STAFF RECOMMENDATION
1612 Lillian Street
November 18, 2015

Application: New construction-addition
District: Lockeland Springs-East End Neighborhood Conservation Zoning Overlay
Council District: 06
Map and Parcel Number: 08314023200
Applicant: Rich McCoy
Project Lead: Paul Hoffman, paul.hoffman@nashville.gov

<p>Description of Project: Construction of a rear addition to a historic home.</p> <p>Recommendation Summary: Staff recommends disapproval of this application, finding that the addition fails to meet the design guidelines for appropriate scale, specifically Sections II.B.2 and II.B.10.a and the Secretary of Interior's Standards.</p> <p><i>Staff has not recommended approval with conditions, as reducing the size of the addition would likely require a full redesign.</i></p>	<p>Attachments A: Photographs B: Site Plan C: Elevations</p>
---	--

Figure 2. The footprint of the proposed addition, compared to the existing footprint.

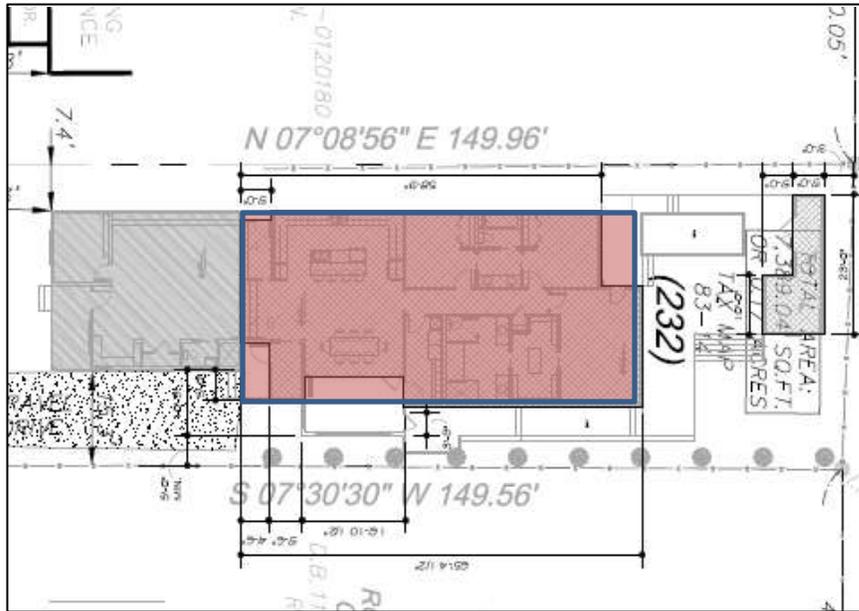
The footprint of the proposed addition is one thousand, eight hundred and fifty square feet (1,850 sq. ft.). The footprint of the existing house is eight hundred and seventy-seven square feet (877 sq. ft.) The proposed added length is sixty-five feet, four inches (65'4"), compared to the existing thirty-one feet (31') of the house. Italicized information in section II.B.10 of the design guidelines for Additions reads *“No matter its use, an addition should not be larger than the existing house, not including non-historic additions, in order to achieve compatibility in scale.”* The purpose of this clarification and interpretation is so that an addition will not “will not disturb either front or side facades,” as outlined in section II.B.10.a, assure that the new construction is “compatible” as outlined in section II.B.2 and to meet the Secretary of Interior Standards, as mandated by state law. Secretary of Interior Standard #9 states, “new work shall be...compatible with the massing, size, scale and architectural features to protect the historic integrity of the property and its environment.” In the past, the Commission has found that additions that more than double the size of the home are incompatible with massing, size and scale of the historic building.

Staff finds that the proposed addition will meet section II.B.1 for height, but does not meet section II.B.2 for compatibility in scale.

MAIN LEVEL PLAN

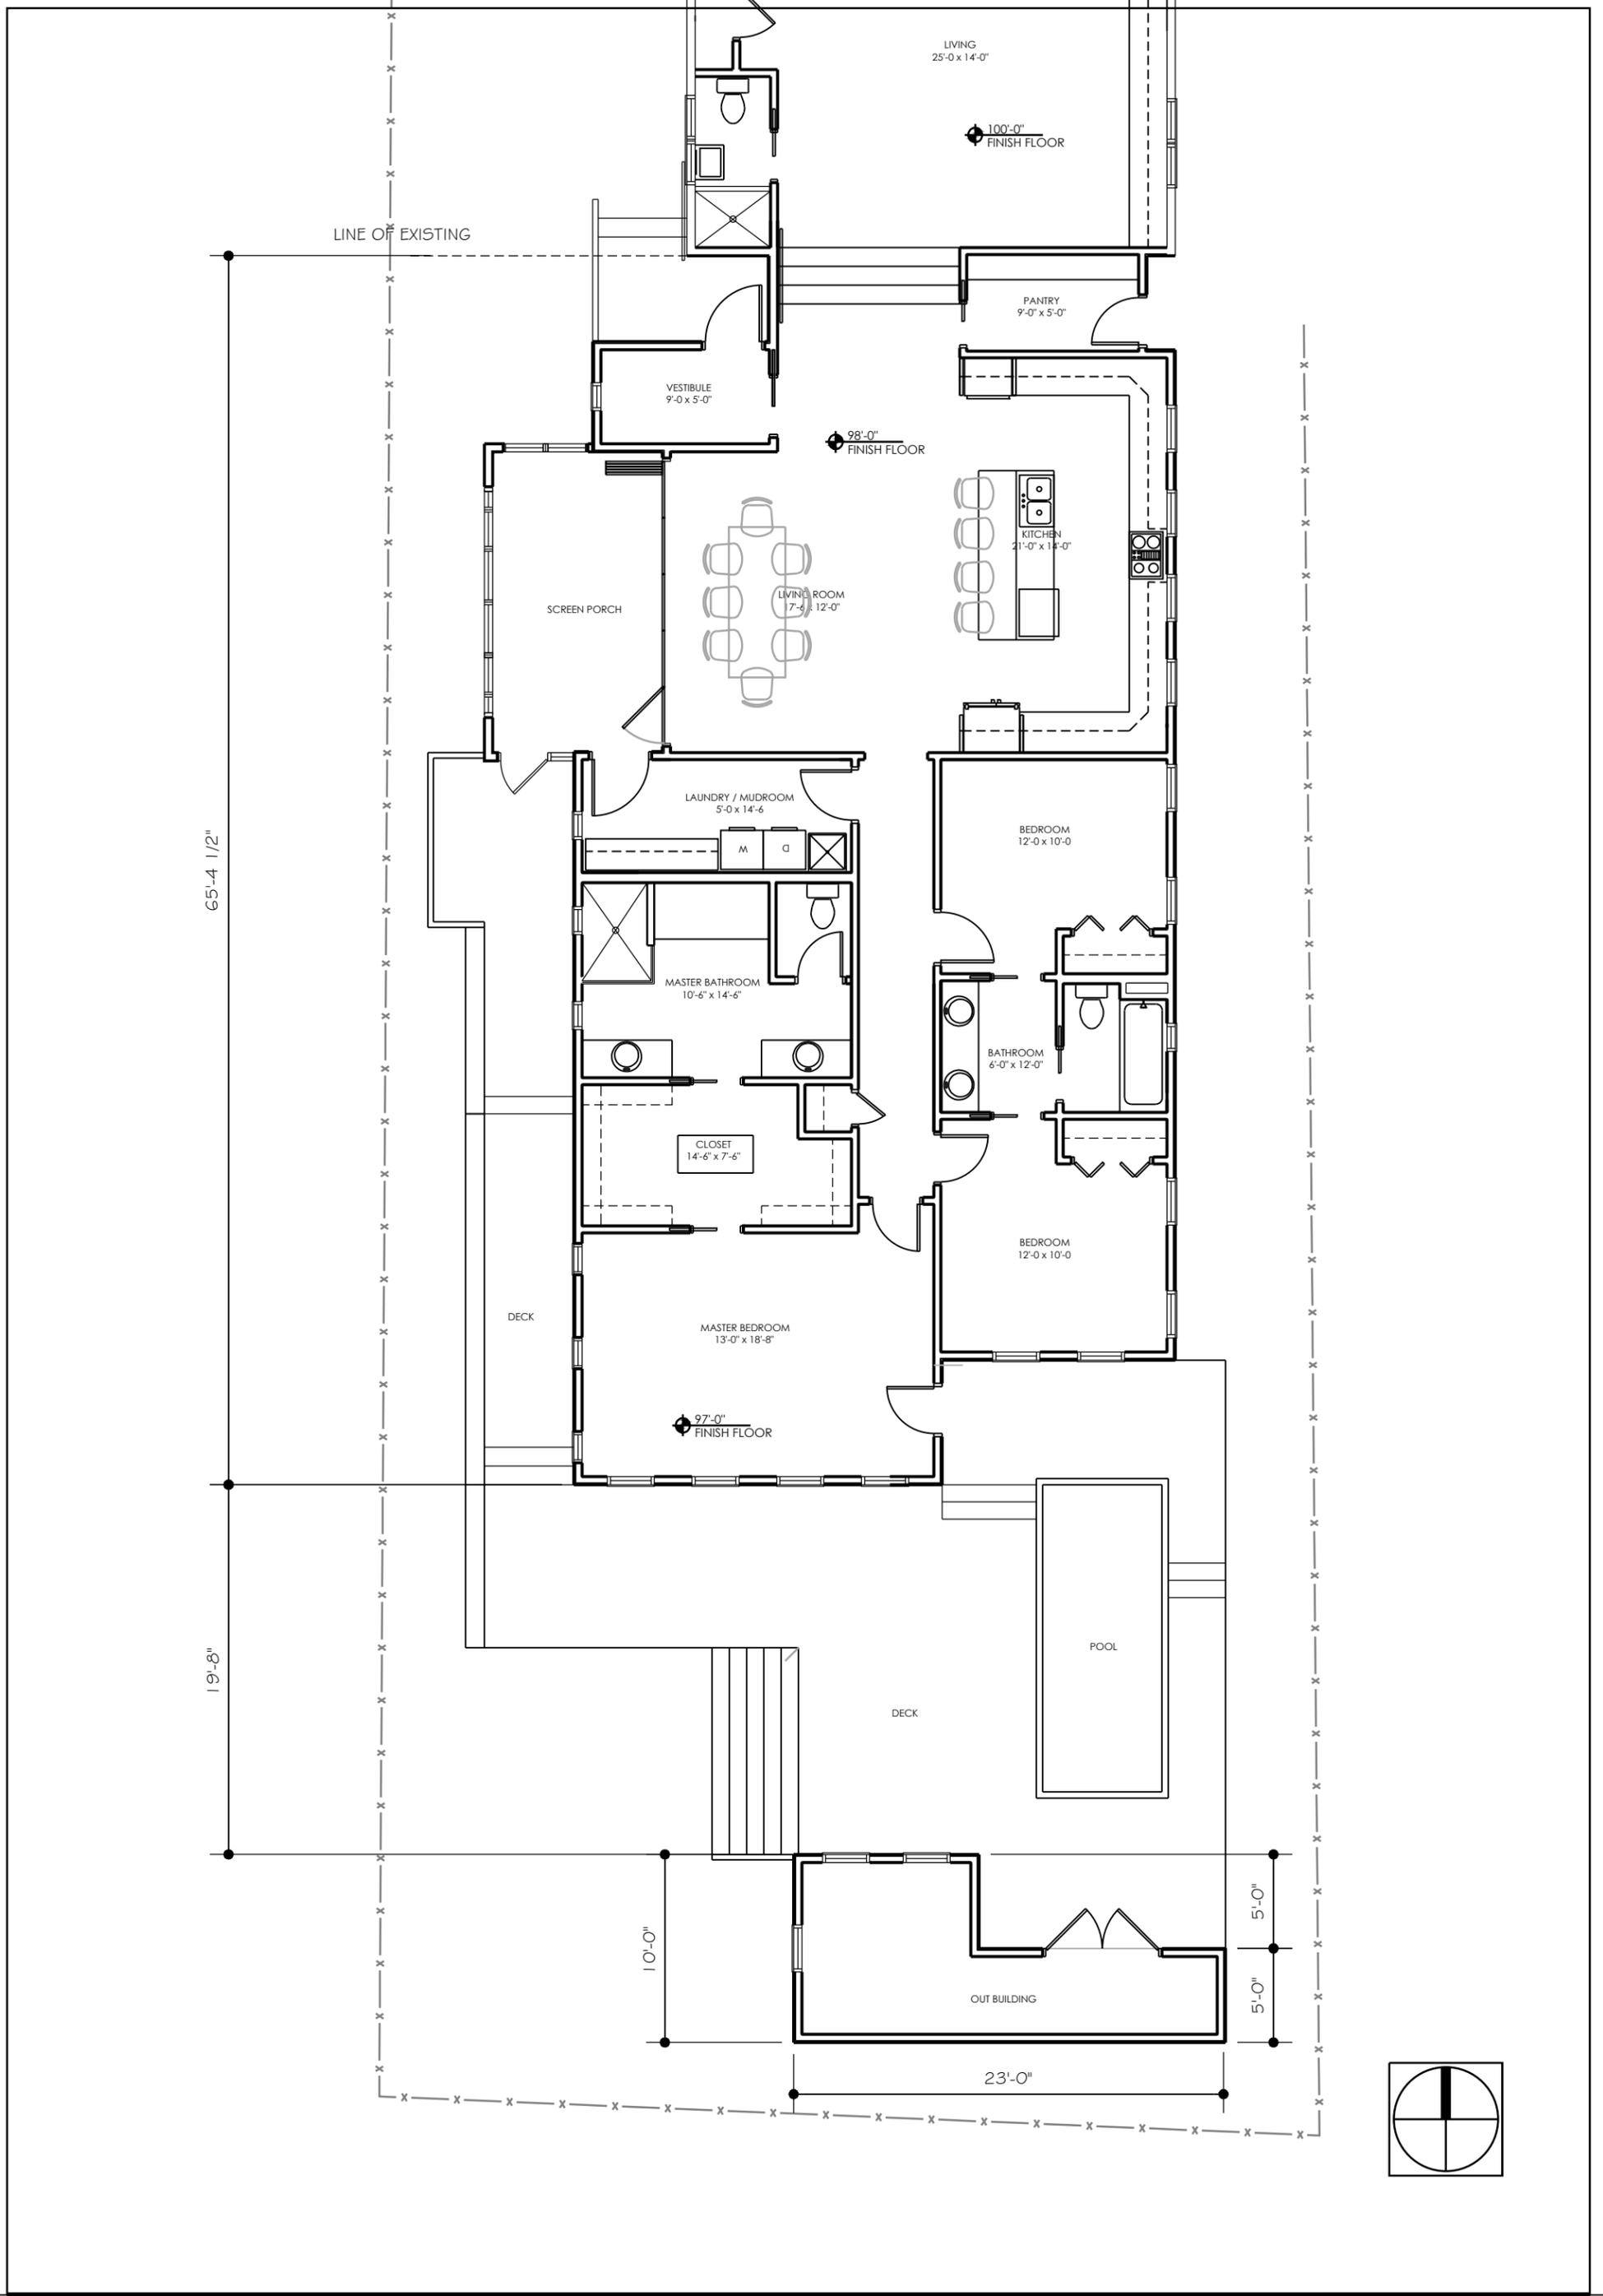
Height & Scale: The addition’s height is approximately one foot (1’) lower than the ridge of the house. The proposed eave height and foundation height match those of the house. To the rear of its insets, the addition’s width is approximately six feet (6’) wider than the house; the screened porch adds another four feet (4’) of width for a distance of sixteen feet (16’). Staff finds the added width to be acceptable in this case, as the historic building is very narrow, at only twenty-six feet (26’) wide, and is also offset on the lot.

Design, Location & Removability: The location of the addition to the rear of the house is appropriate. The design, material change and insets differentiate it from the existing structure. The addition is distinguished from the existing structure with insets of four feet (4') on the right side, and one foot, six inches (1'6") on the left. If the addition were to be removed in the future, the integrity of the historic building would remain. The project meets section II.B.10.a, and d.

EAST ELEVATION

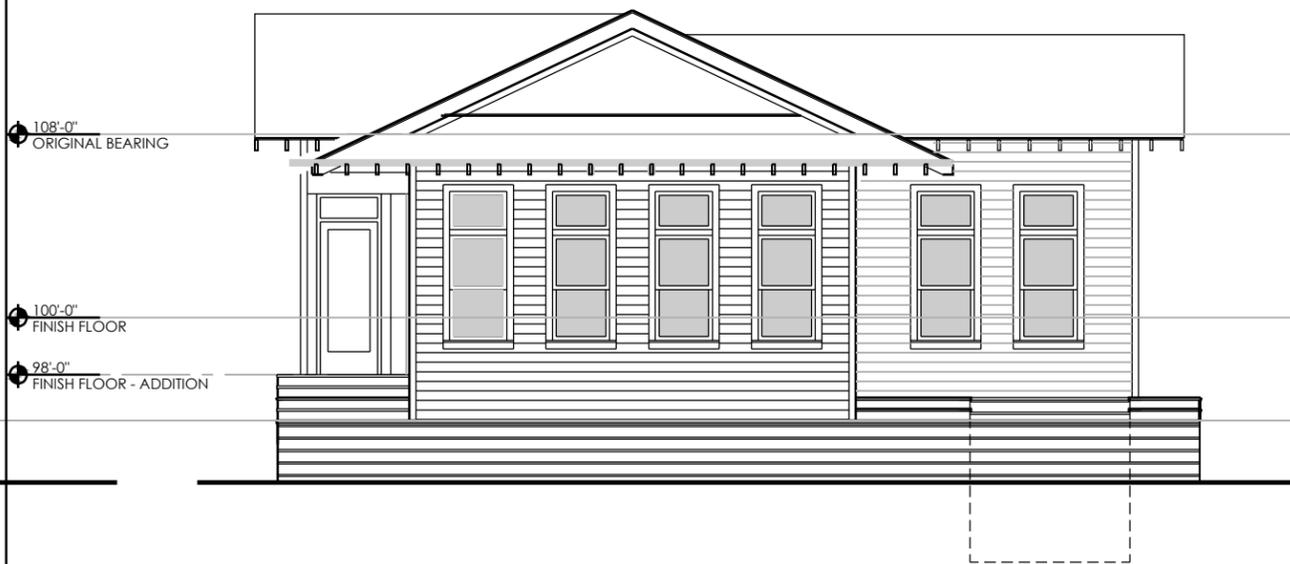
Roof form: The addition's roof is a gabled form with 6/12 pitch. The screened porch roof and towers on the east elevation feature the same roof form and pitch. The roof form is common in the district, and the project meets section II.B.5.

Proportion and Rhythm of Openings: The windows on the proposed addition are generally twice as tall as they are wide, meeting the historic proportions of openings. There are no large expanses of wall space without a window or door opening. There are four horizontal windows on the east elevation; the Commission has discouraged these windows except when they read as a transom or are toward the rear of the new construction. As these are toward the front of the addition, Staff would recommend that these windows be redesigned to a more historic proportion. With this revision, the project would comply with section II.B.6 for proportion and rhythm of openings.
